**Office Action Summary**

09/097,023

MCFADDEN ET AL.

**DETAILED ACTION**

**Fig. 2**

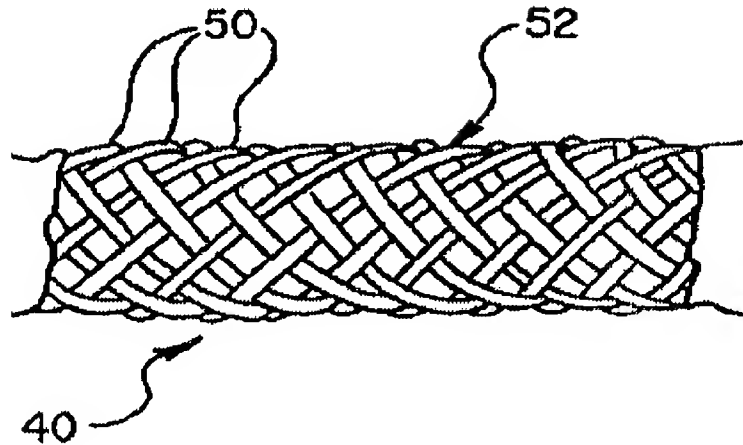
7. Applicant's arguments filed 07/12/01 have been fully considered but they are not persuasive. Applicant's arguments are primarily directed to the Rejections under 35 U.S.C. 102(b) and independent claims 1, 24, and 31. Applicant's entire argument rests on the difference between a "weave" and a "knit". Applicant primarily argues that, "Interlacing strands cannot be the equivalent of interlacing in a series of connected loops because in a knit, individually formed loops are connected together.....whereas in a weave, no such loops exist." While the Examiner still contends that given the multiple definitions given to the word "knit" that the interpretation of a braid or weave may still read on a knitted structure one might still focus on the series of connected loops. When looking at the braided, weaved, or knitted structure in Figure 2, one might notice the loop structure that occurs with any given strand within the weave.

In fact, connected looping does occur in the braid pattern above if one considers the orientation of the loop. Notice the strand that is touched by reference number 52. Follow that strand down toward the region where reference number 40 is located. This provides one view of the side of the loop of a given strand. If you can then imagine following the same strand around the tubular device to the other side, in fact a loop structure has been made. Furthermore the examiner would contend that this looping occurs continually as the strand moves longitudinally. In much the same fashion, each of the remaining strands also loop around the device and are in series each "connected" to each other inasmuch as connection can be loosely defined. In either event, Applicant only uses the word "knit" in the claims and doesn't necessarily define or state such loops and their relationships, orientations, or structural connectivity.
